Subject: **Special Use Application** — 2003 S. Croatan Hwy in the Commercial Zone - Add Outdoor Dining Activity Area

Re: Site Plan Technical Review1 – Noosa Beach Grille, 2003 S. Croatan Hwy

Project: **Noosa Beach Grille**
Project No: **20049**
Location: **2003 S Croatan Hwy Kill Devil Hills, NC**
Title: **Parking Plan**
Date: **November 9, 2021**
Scale: **1" = 20'-0"**

1 Site Parking Diagram
1" = 20'-0"

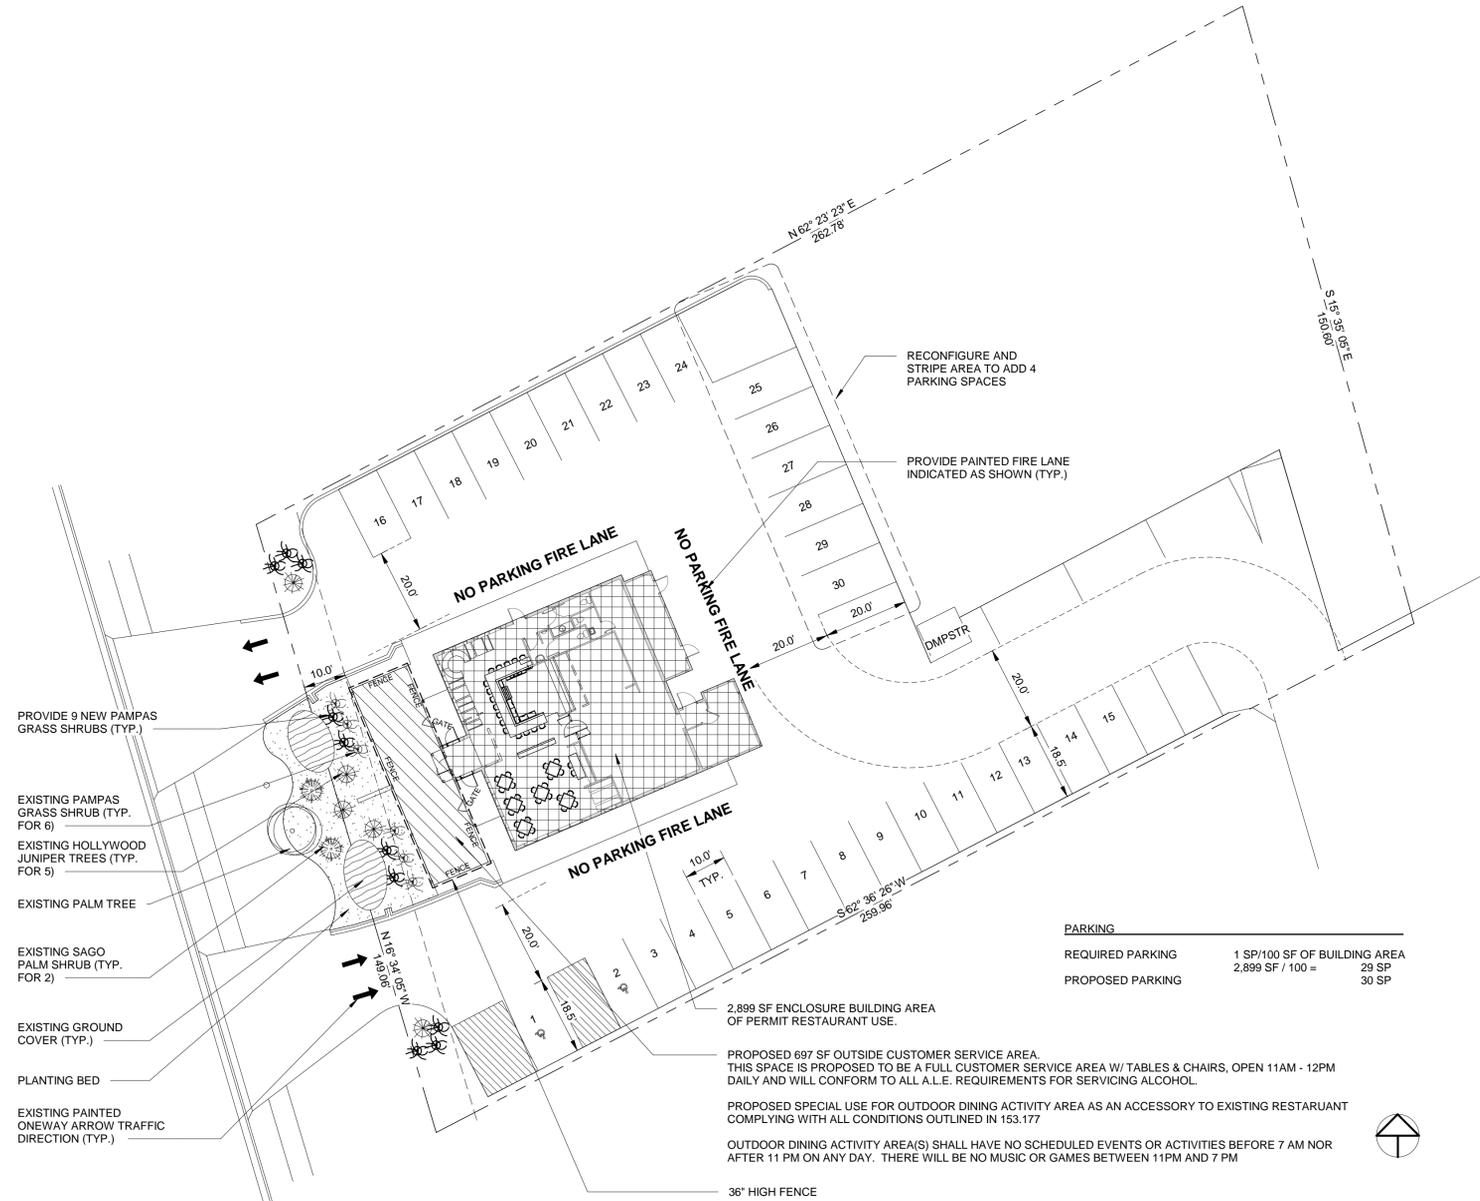
1. Fence bordering Outdoor Dining Activity Area shall be four feet in height 153.177(H). Existing fence is only 36".

- Provide directional arrows for drive aisles that access US158. Both are one way due to drive aisle width
These are currently existing at the site and have been added to the Site Plan.

- Provide parking space widths
All parking spaces are 10' wide and a typical note has been add to the Site Plan.
- Provide distance of proposed "Outdoor Dining Activity Area" from western property line. Shall be a minimum of 10' from property line to meet buffer requirements
A 10' setback line has been added to the Site Plan and the Proposed Outdoor Dining Activity Area is outside of this setback.

- Landscaping requirements: Front property line shall meet landscaping requirements. All required plantings shall be on the property, not located within the ROW. Minimum plantings shall be (5) trees and (15) shrubs (150' property line: 1 tree per every 30', 1 shrub per every 10'). Landscaping may be dispersed anywhere along the front property line within the 10' buffer (North and south side of drive aisles currently show no landscaping)
The site currently has 5 Hollywood Juniper trees meeting size requirements and 6 Pampas Grass shrubs. 9 additional Pampas Grass shrubs are proposed in the landscape buffer and shown on the Site Plan.

- Revise note: "Fence" to include total height
The existing fence is 36" tall and is noted on the site plan.

- Gates shall swing toward egress travel out of that space.
The occupant load served by these gates is less than 50 and by NCBC 1010,1.2.1 not required to swing in the direction of travel.
- Occupancy Load shall be calculated for that space and the main restaurant as well and posted
Occupancy calculations are included on the Appendix B drawing sheet A001.
- Appendix B required for this space
This space has been added to the Life Safety drawing on sheet A001.
- Drive lanes around the building were designated as fire lanes and it does not show it on the site plan
The notes "NO PARKING FIRE LANE" has been added to the Site Plan.
